ROLLESTON COAL EXPANSION PROJECT

Amendment to
Regional Interests Development Application
Glencore RPI16/RPI/001

12 September 2016

Figure 1 - Site Layout

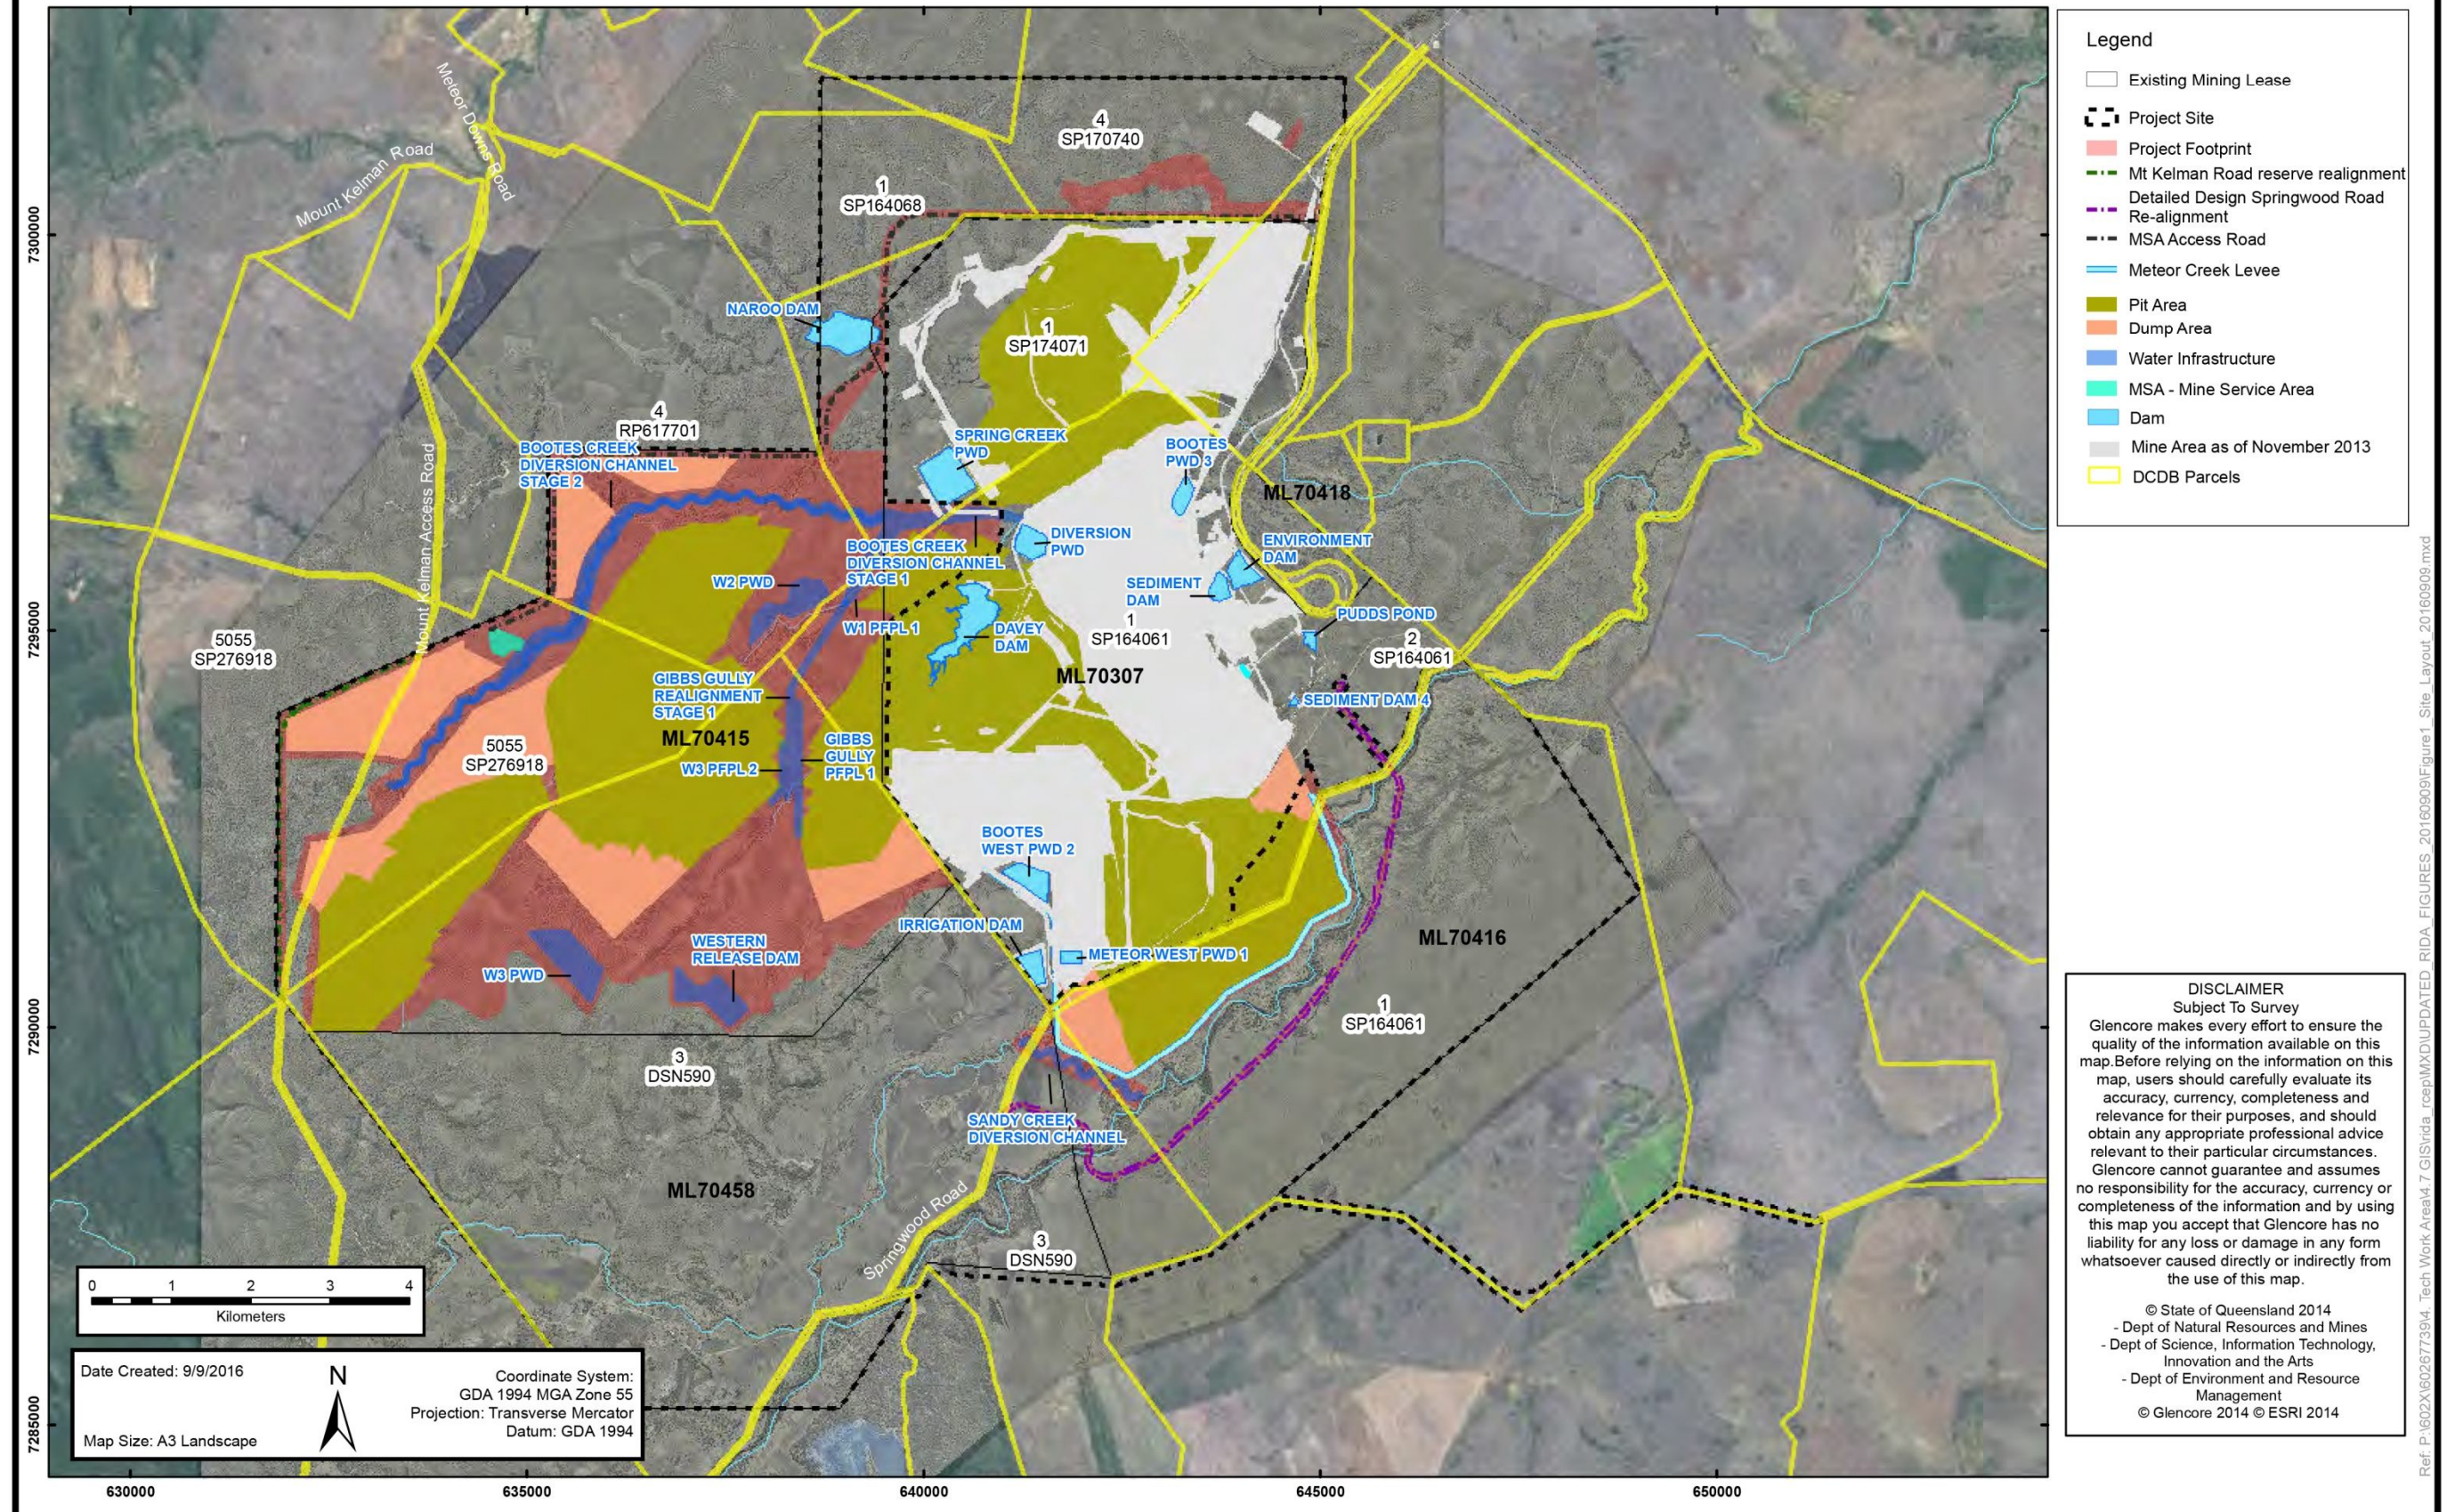
- 2.10 Figure 1 (overpage) provides an updated overview of the Project Site and the revised Project Footprint, taking the above changes into account. The April 2016 application also noted that while the RCEP leases encompass approximately 12,758 ha of land, mining was not proposed within the full extent of the Project Site, with direct impacts (the Project Footprint) constrained to a smaller area of some 5,405 ha. With the above changes, the RCEP footprint is now reduced to 5,319.02 ha.

Figure 2 - Potential PALU Identified in the Study

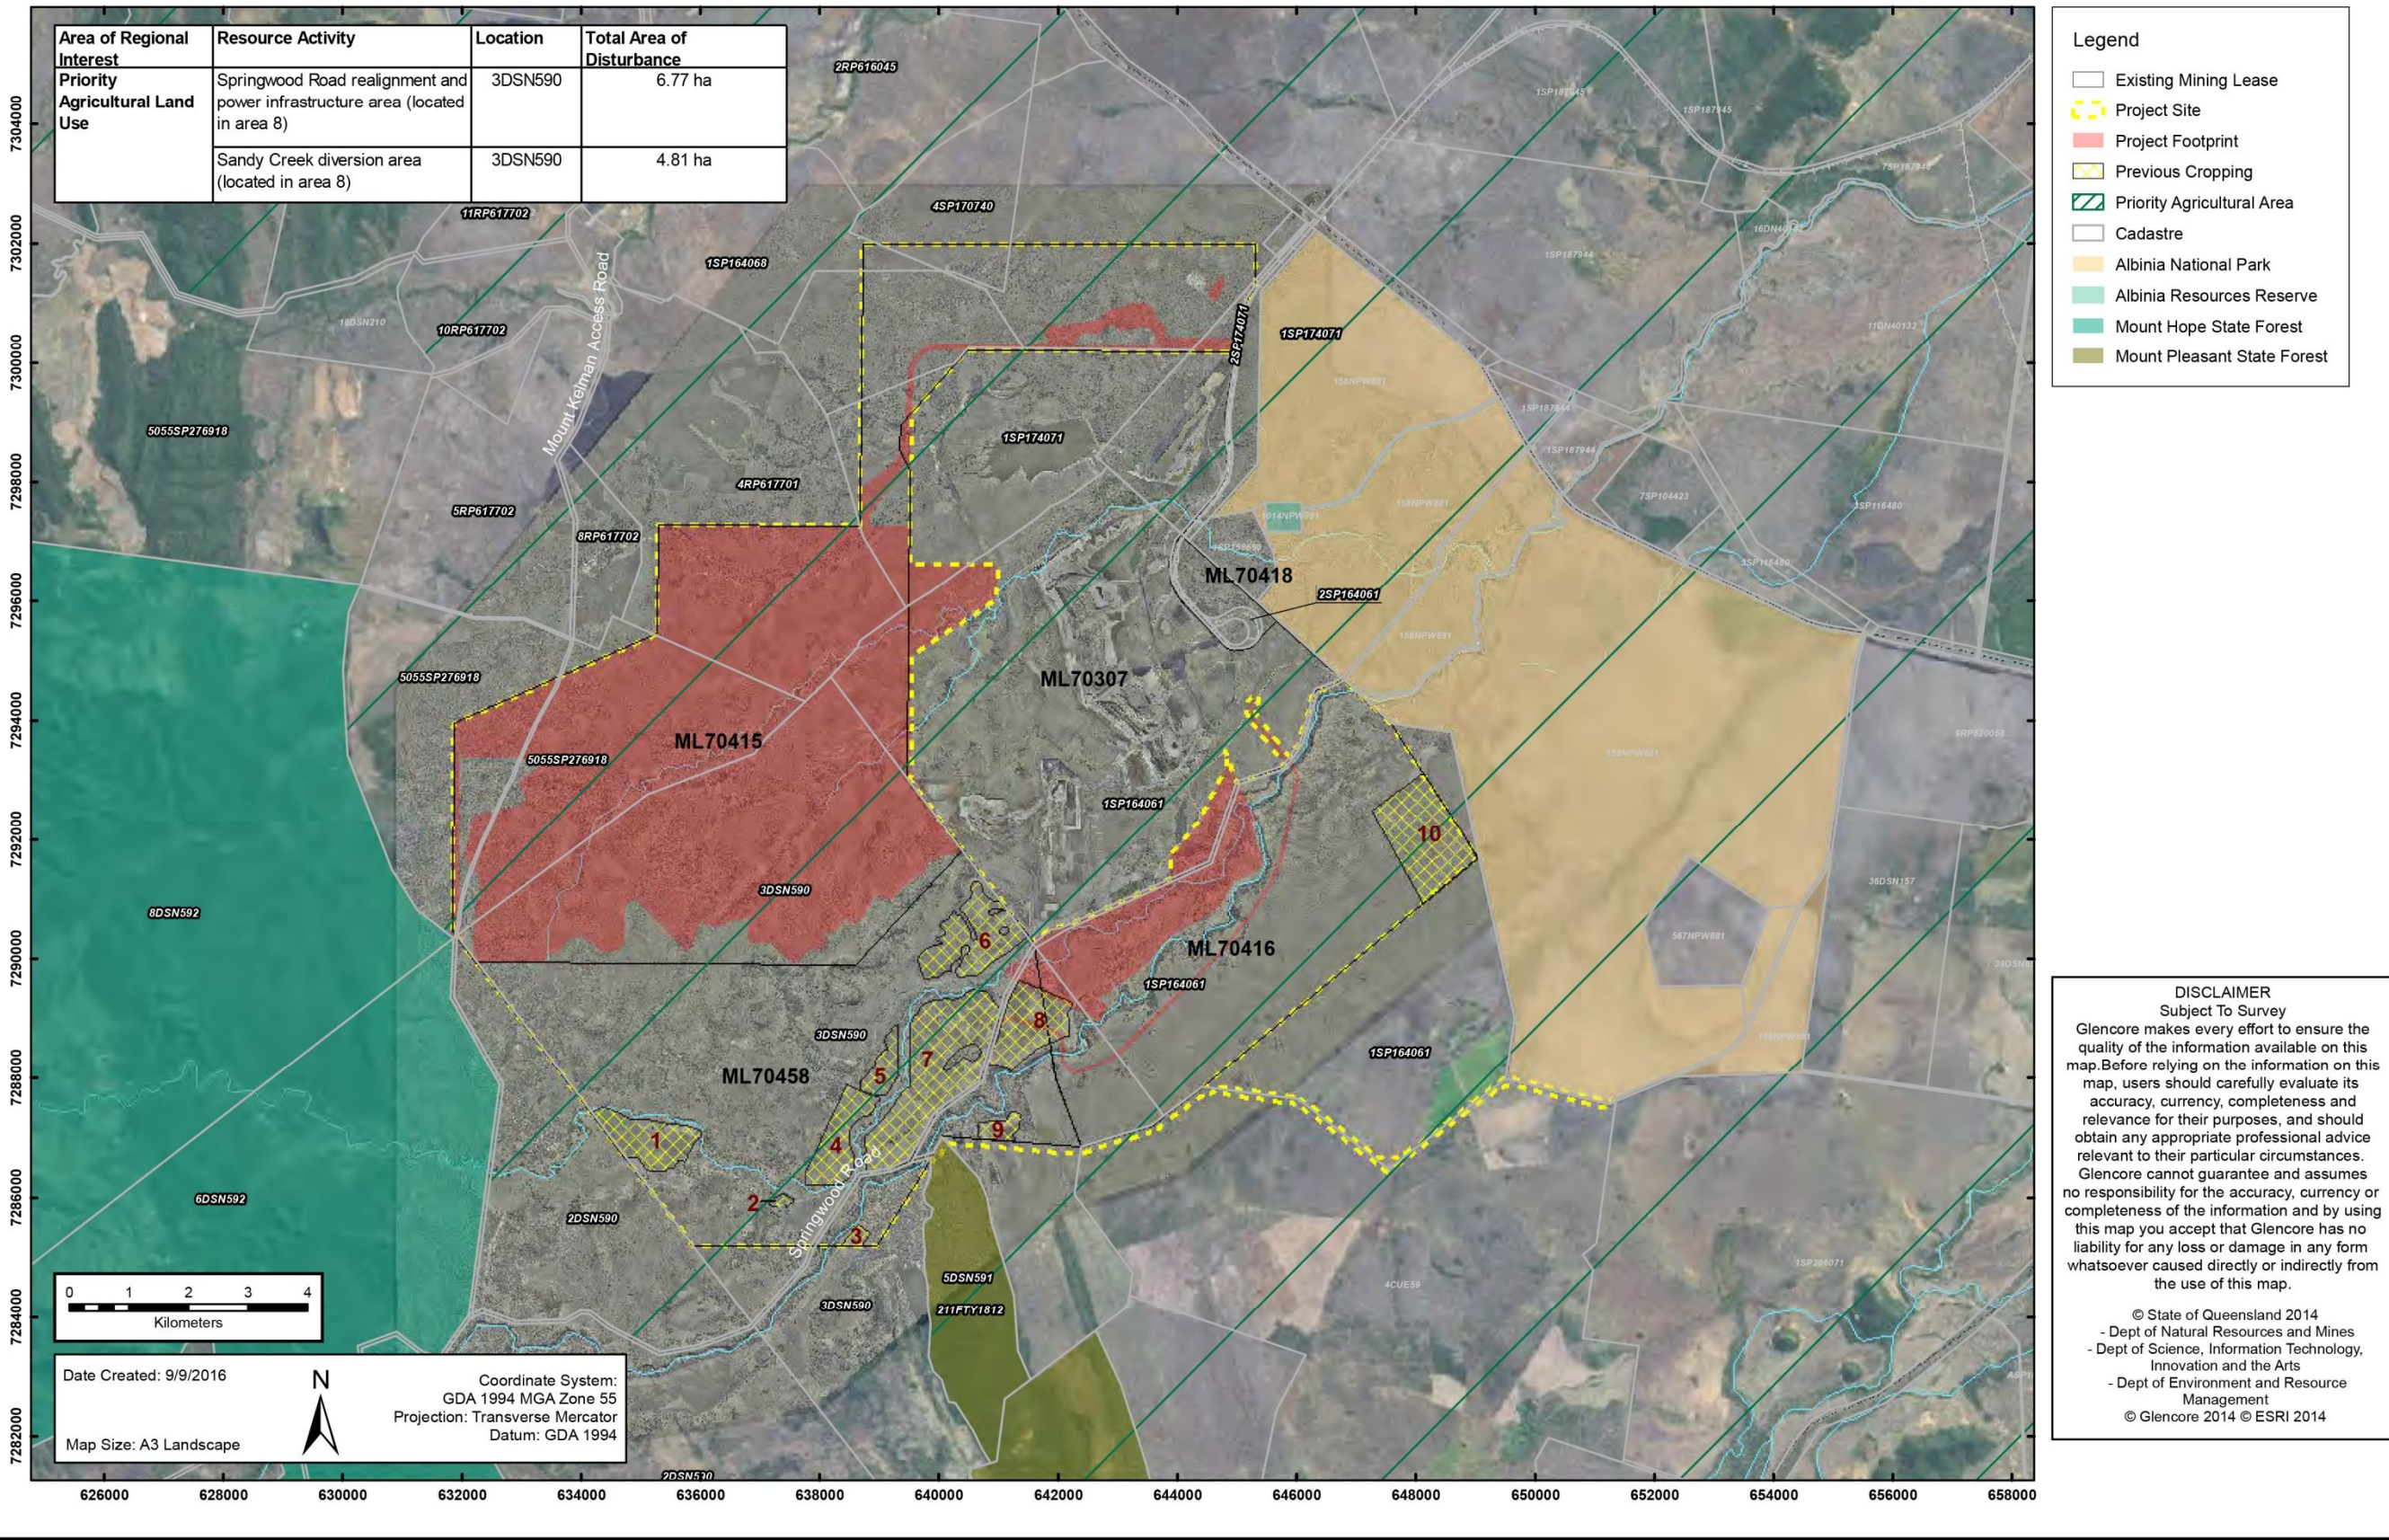
- 3.2 Figure 2 identifies the regional extent of PAA (relative to the Project) based on current government mapping, and the impact the RCEP has on PALU within the identified PAA.

- 3.3 Following the changes as outlined in section 2, the extent of impact on PALU has now been reduced to 11.58 ha. As there is an impact on an area of regional interest, an assessment has been undertaken for the PAA provisions of the RPI Regulation (that is, Schedule 2, Part 2), on the same basis/reasons as outlined with the original (April 2016) application material.

Figure 4 - Areas of Regional Interest (Strategic Cropping)

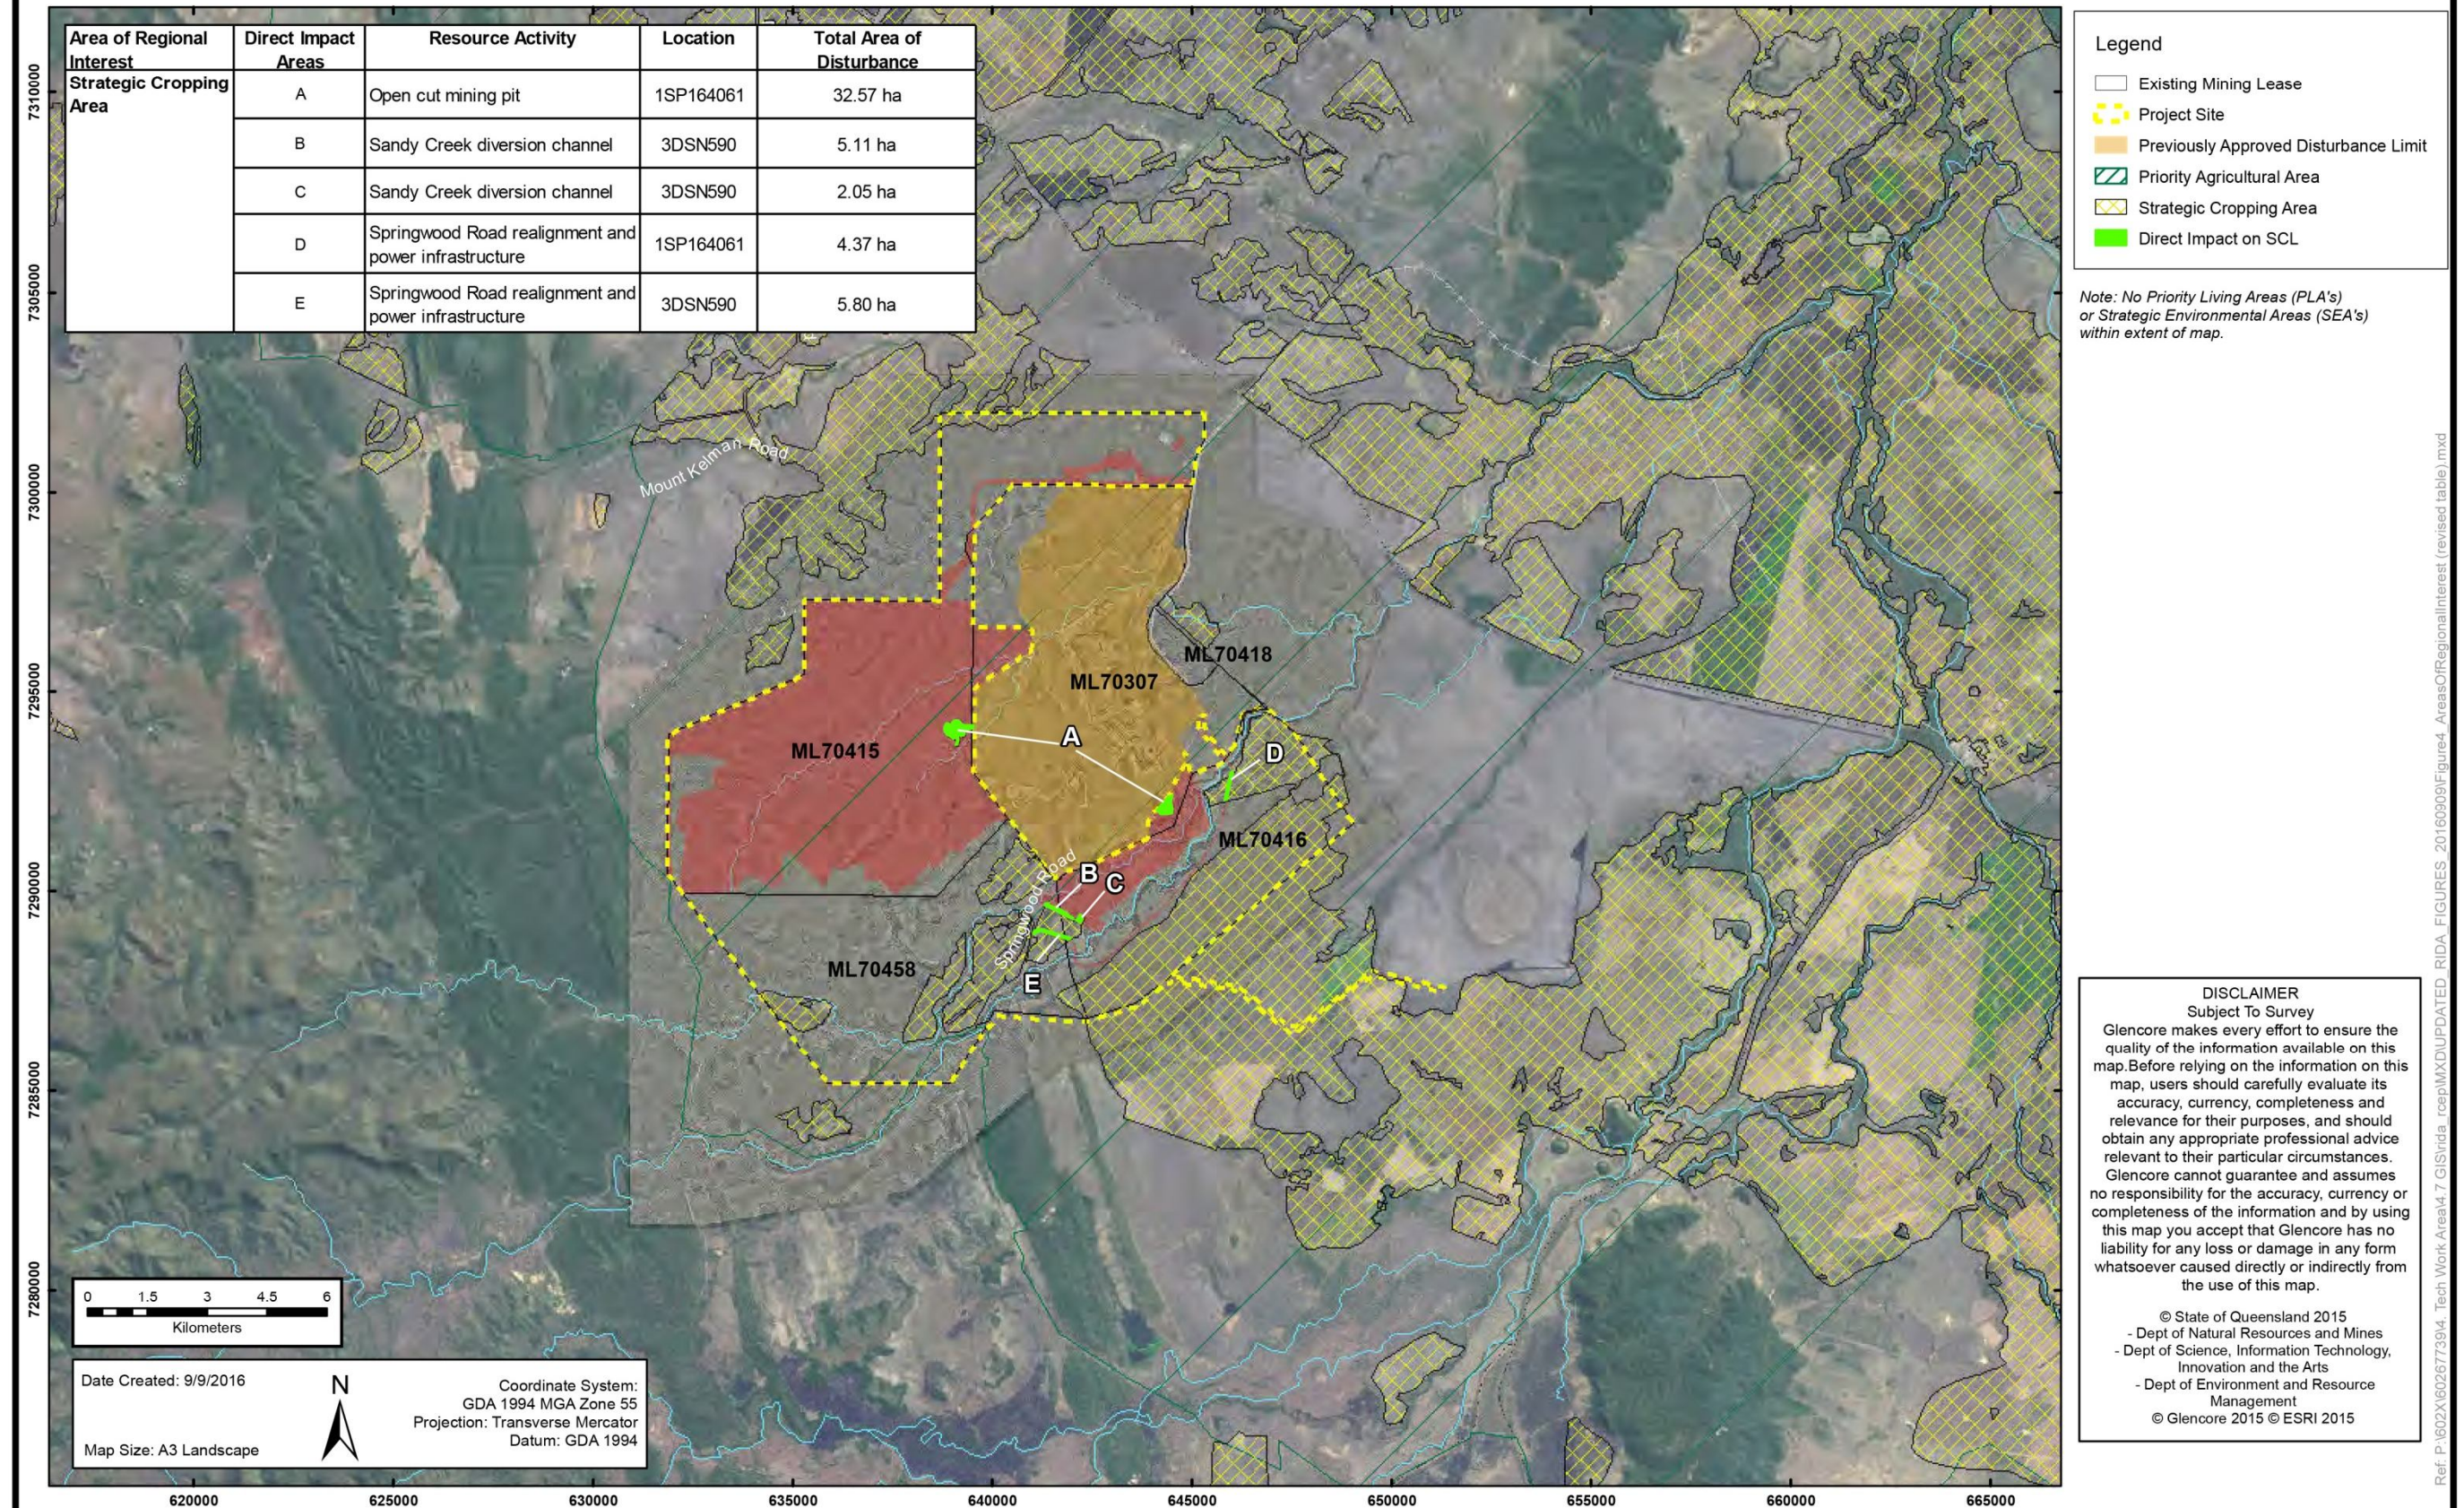
- 3.13 As outlined within the original (April 2016) application, the RCEP footprint includes area of land mapped as SCA. With the changes as outlined within section 2, 49.90 ha of the RCEP's disturbance footprint is mapped as SCA, as set out in Table 2 below and Figure 4.
